MODEL
2022-2024MY
Carnival (KA4)

NUMBER
PS788

FUEL FILLER DOOR ACTUATOR REPLACEMENT

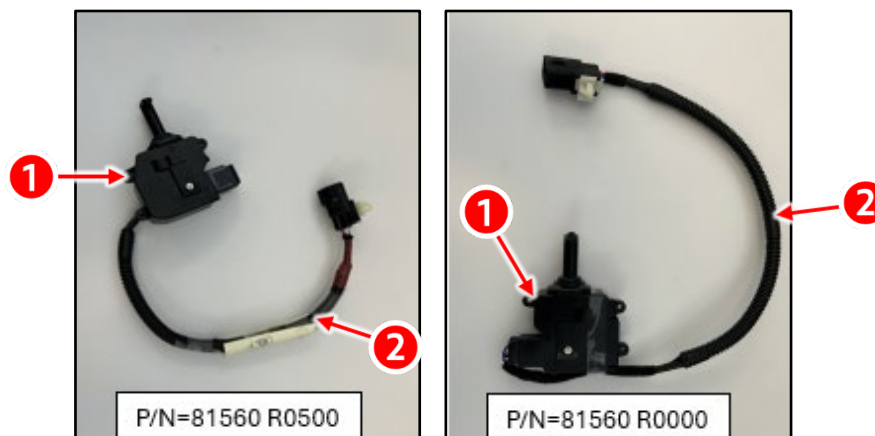
This Pitstop provides information regarding the replacement of the fuel filler door actuator and wiring harness on 2022-2024MY Carnival (KA4) vehicles. When replacing a faulty fuel filler door actuator, ensure to order the corresponding replacement part number (shown below) for the applicable vehicle production date. Selecting the incorrect part may result in a vehicle “comeback” with a customer complaint of the driver’s side sliding door not operating with the power feature; however, the door can still be operated manually.

NOTE: Both the fuel filler door actuator (1) and the included wire harness (2) must be replaced together. (DO NOT replace the fuel door actuator using the old/existing wire harness on the vehicle).

PNC	Part Name	Part Number	Qty	From	To
81230G	OPENER ASSY-FUEL FILLER DR	81560-R0000	1	01-04-2021	10-23-2023
		81560-R0500	1	10-23-2023	07-04-2024
